STATE OF NORTH CAROLINA
DEPARTMENT OF TRANSPORTATION

Subject: **Additional Information for Section 404 Individual Permit and Section 401 Water Quality Certification** for US 421/NC 87 Bypass from East of SR 1521 to east of NC 42, Lee County; Federal Aid Project No. STP-NHF-421(2), WBS Element No. 34431.1.1, Division 8, **TIP No. R-2417AB**

ADDITIONAL INFO. SHEET 1 OF 4

ADDITIONAL INFO SHEET 2 of 4

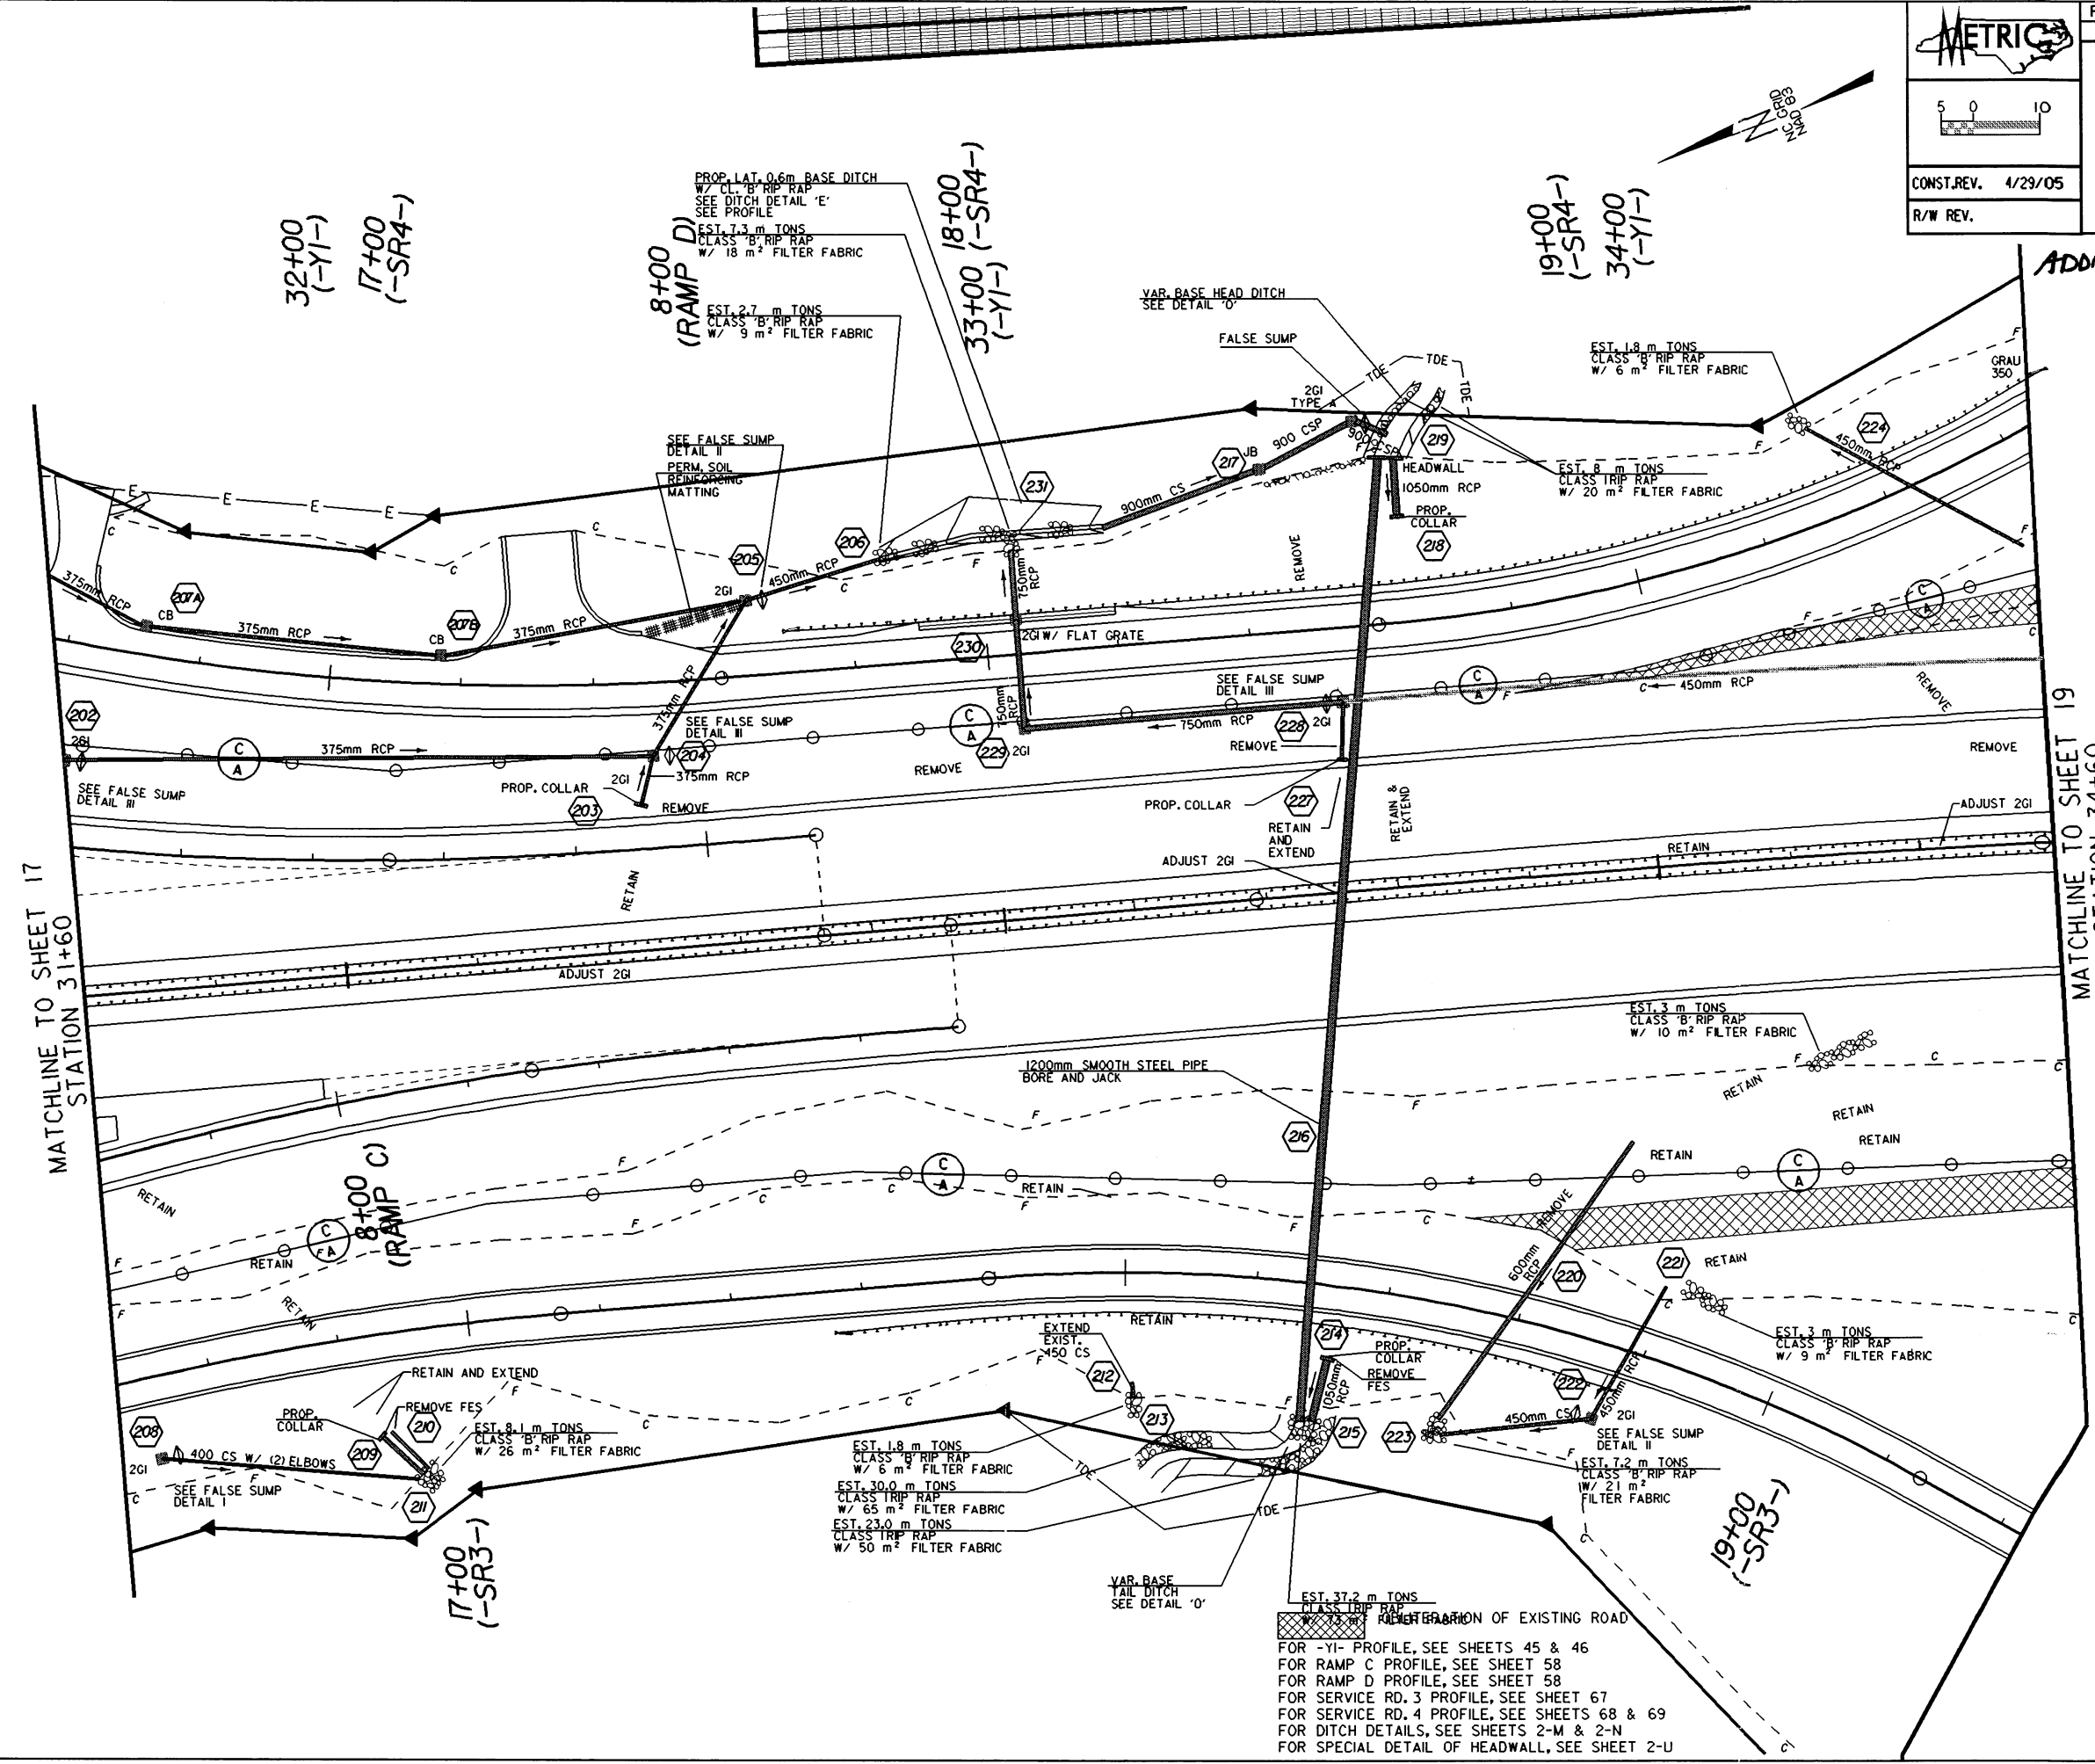
The purpose of this letter is to provide the US Army Corps of Engineers (USACE) and the NC Division of Water Quality (DWQ) with additional information regarding the North Carolina Department of Transportation's (NCDOT) activities to address an on-going erosion problem at the inlet side of Permit Site 10 (Station 18+62 SR4 LT / Station 33+50 Y). The erosion is occurring at the 36-inch (900 mm) CSP outlet pipe, located approximately 50 feet from the jurisdictional stream, that outlets stormwater drainage. Despite attempts to stabilize the area with riprap, scour hole, etc., there is continued erosion. The NCDOT will be extending the outlet to the stream in a pipe system with drainage structures that have drops in elevation. The drops will act to dissipate energy. The outlet pipe will be placed at 0.00% to minimize velocity. The 10-year outlet velocity is estimated at 3.1 feet per second (ft/s). The placement of the additional approximately 66-foot long section of pipe will be within the footprint of the permitted impacts. As such, no additional impacts will occur.

CONSTRUCTION REVISION - 04/29/05 - ADDED DOUBLE FACED CONCRETE BARRIER AND REVISED DRAINAGE ON -YI-
